## Methane Detection System Will Not Warn the Operator if the System Loses Power

<b>Title (metadata)</b>	21PBN / 21KWH – LNG/CNG Methane Detection System Will Not Warn Operator if System Loses Power – NHTSA ID: 21V00N, TC: 2021-793
<b>Bulletin No.</b>	21PBN / 21KWH
<b>Description</b>	21PBN / 21KWH – LNG/CNG Methane Detection System Will Not Warn Operator if System Loses Power
<b>Supplier</b>	Peterbilt / Kenworth
<b>Section</b>	Fuel - 44
<b>What's New Abstract</b>	<b>Safety Recall</b> – The methane detection system will not warn the operator if the system loses power. The driver could be unaware of an issue with the methane detection system or excessive methane present, increasing the risk of a fire, crash, or injury.
<b>Revision</b>	
<b>Introduction</b>	On certain LNG and CNG vehicles, the methane detection system may not function as designed. The driver may not be alerted by warning lamp and buzzer if the methane detection system loses power.
<b>Situation</b> (Chassis Affected)	PB-244 (241 US / 3 Canada) Model 536, 567 and 579 chassis model year 2016 through 2022 LNG and CNG vehicles built from 06/01/2015 through 11/30/2021 with a methane detection system.

<table><tr> <th colspa

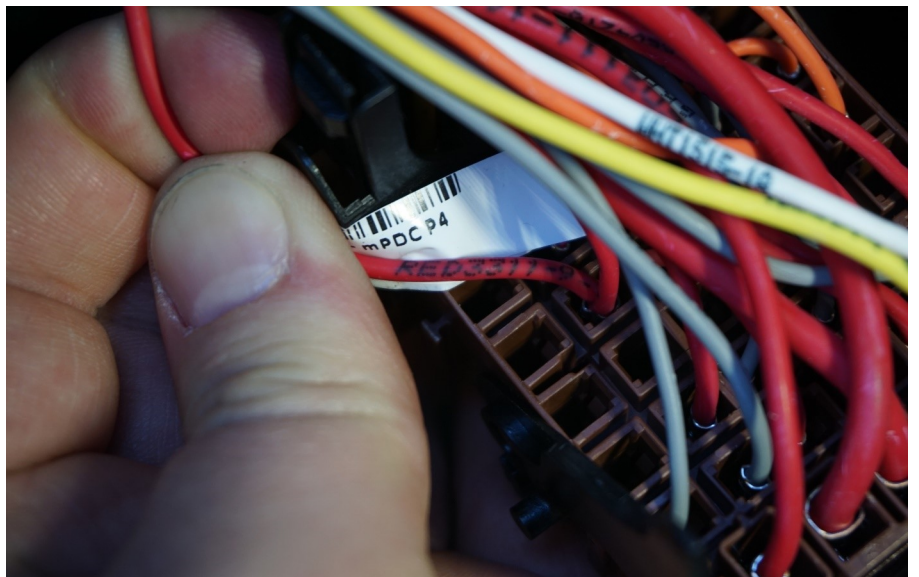
**Step 9:** Locate and cut wire RED 3311-9

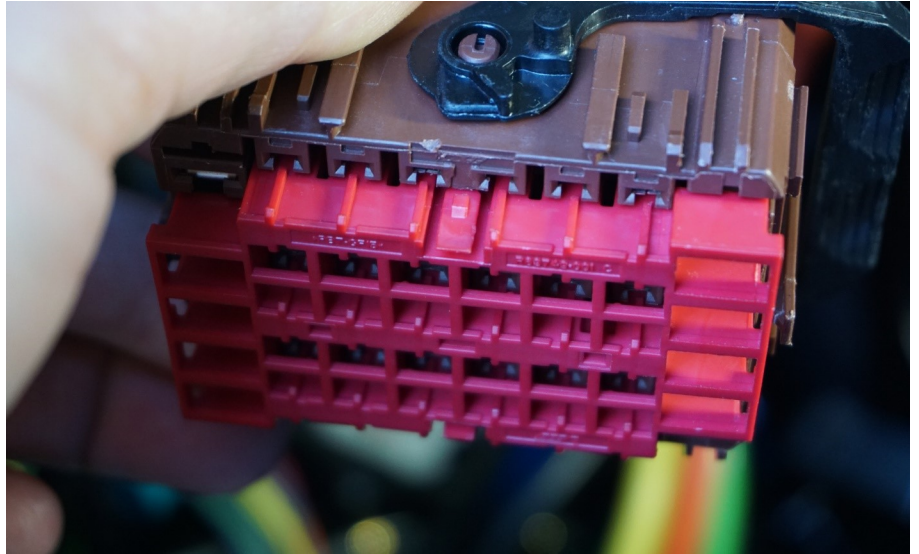
NOTE: The secondary lock must be released in order to add a wire terminal to the connector.

**Step 10:** Add terminal to wire red3311-9 and re-locate to position B4

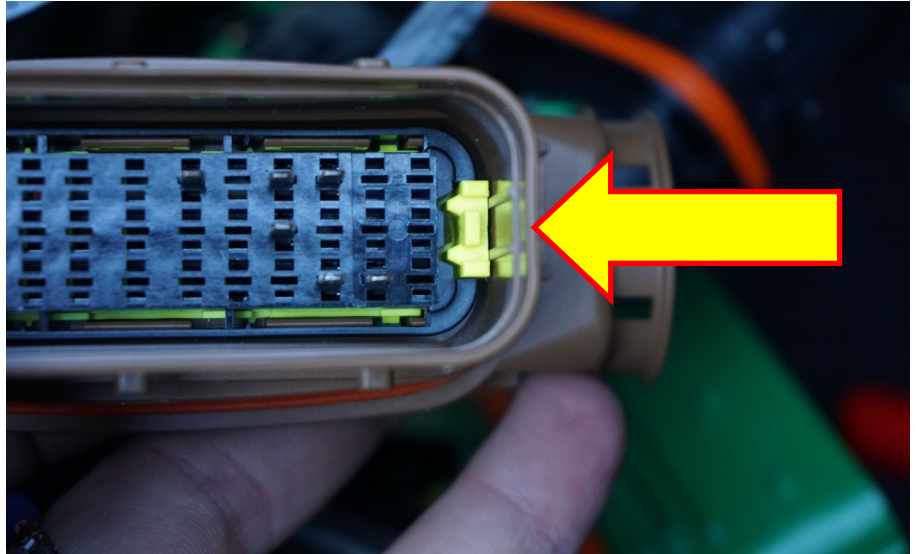
**NOTE:** The secondary lock is released by sliding the yellow tab towards the pins until it clicks.

**The disconnected wires must be cut, then insulated with tape or heat shrink tubing**

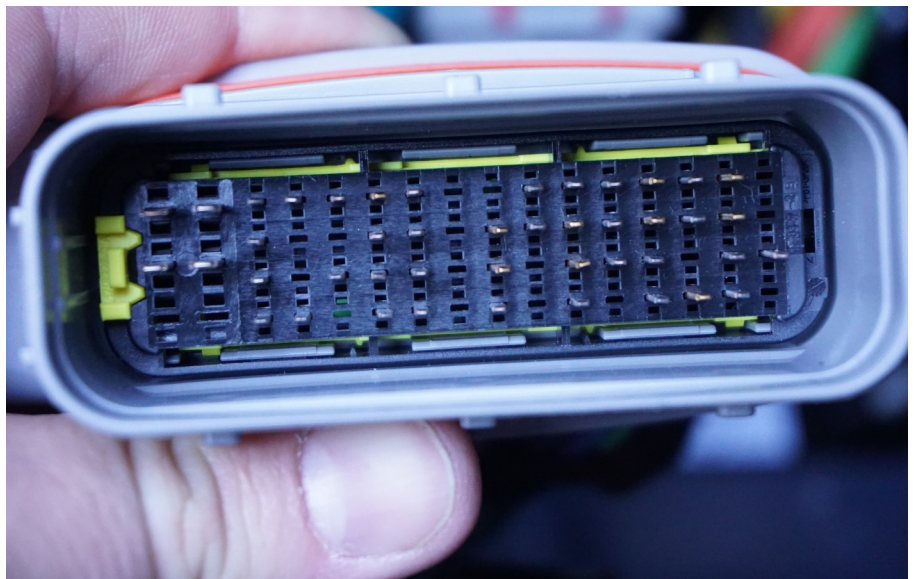
**Step 12:** Replace pin 25 in connector P099 (brown) with RED0731-17 on the rework harness:

**Step 13:** Replace pin 17 in connector P006 (gray) with RED 0731-10 on the rework harness:

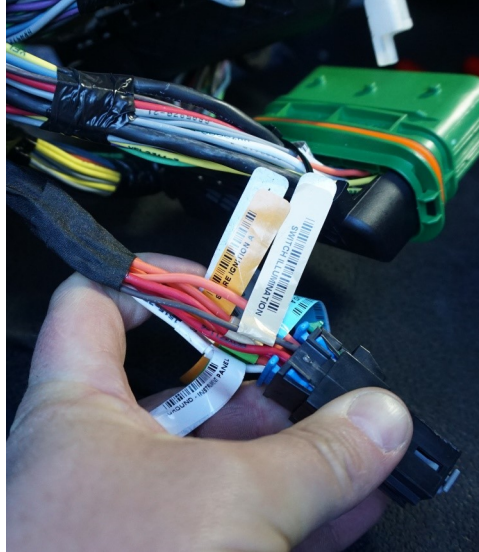
**Step 14:** locate spare power connector (tied back near the firewall pass through connectors) and plug in harness S92-1250-1000

**Step 15:** Plug the rework harness into terminal P04B Spare batt 1

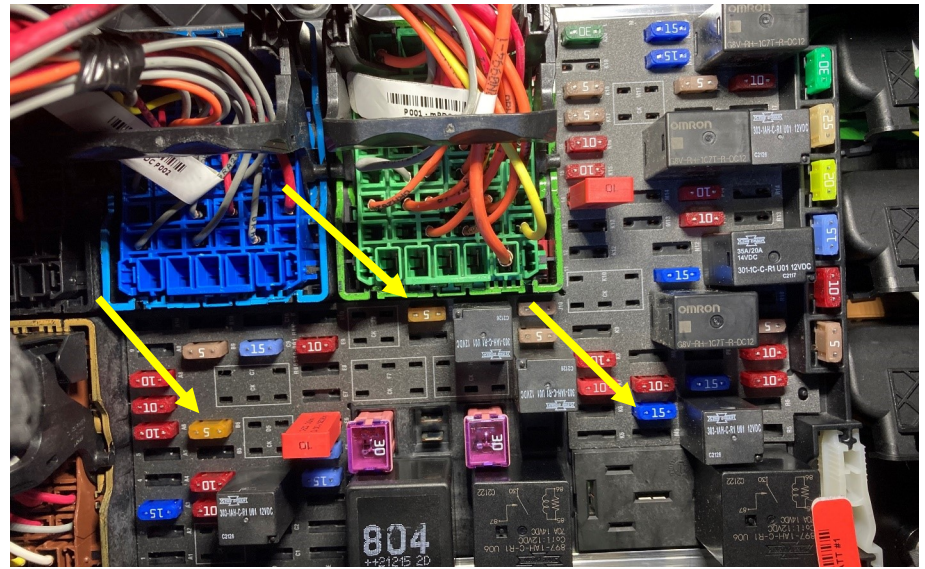
**Step 17:** Re-pin alarm connector power wire with the rework harness, then insulate the unused cable and secure the alarm in its original position.

**Step 18:** Move the 15 Amp fuse in location B6 to M6, then insert 5Amp fuses in locations B6 and G10

Note: location G10 may be populated with a 20Amp fuse from the factory, replace it with the 5Amp fuse

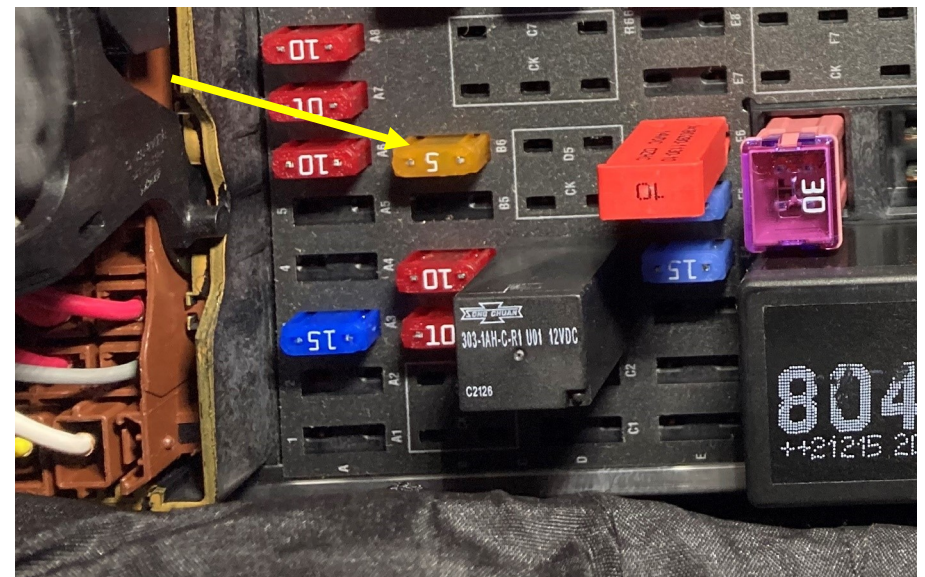
**Step 20:** Correct the fuse labels on the fuse label :

B6-Methane detect (5A)

M- PACCAR AMT (15A)

G10-Methane Detect (5A)
